ADDENDUM NO. 1
TO
PROCUREMENT AND CONTRACTING REQUIREMENTS
FOR
NineStar CR200 Sewer – Division I
FOR
NINESTAR CONNECT
Issue Date: October 25th, 2023

The following, as additions to and modifications in the Bidding Requirements and Contract Documents, will be included in, and become a part of the **NineStar CR200 Sewer – Division I**. This Addendum forms a part of the Contract Documents. Bidders are, therefore, instructed to take the following into account in rendering any Bid for this work. Acknowledge receipt of this Addendum in the space provided on the Bid Form.

BOULDERS LIFT STATION ONE-LINE DIAGRAM

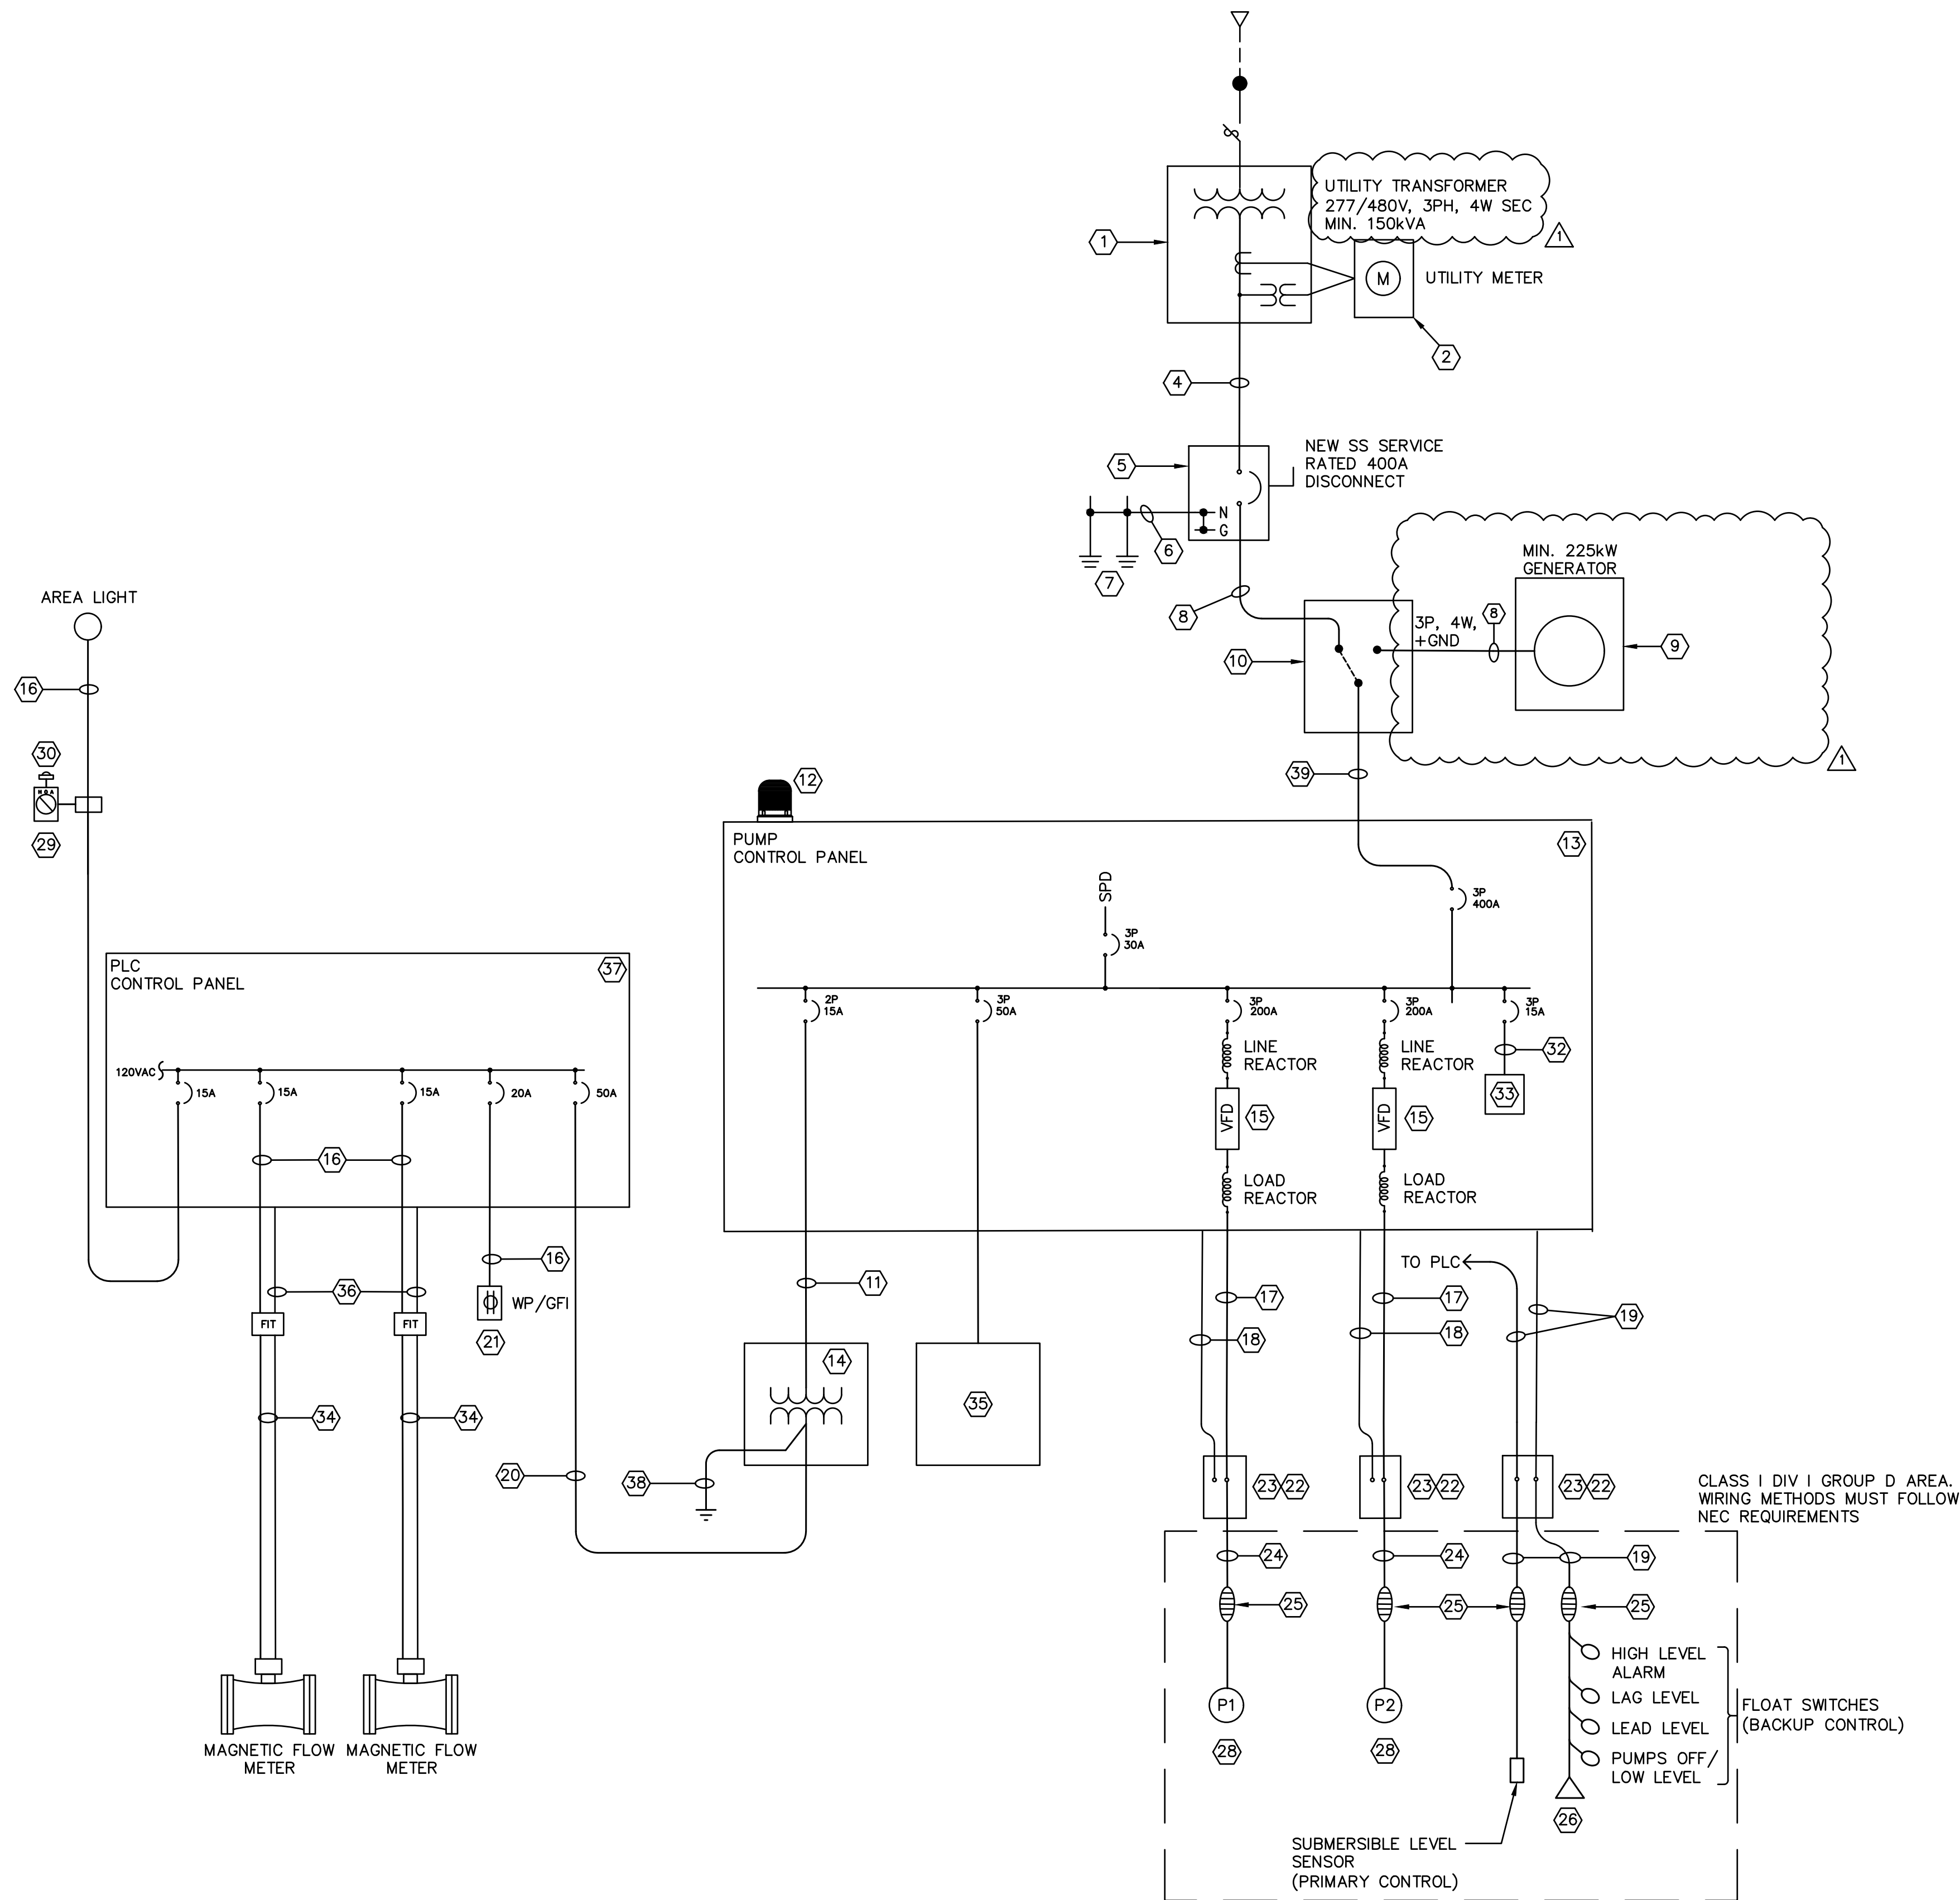
- e. Sheet E200 – Boulders Lift Station Site Plan (Added notes about generator, transformer pad and bollards.)
 - f. Sheet E201 – Boulders Lift Station One-Line Diagram (Added permanent generator and ATS.)
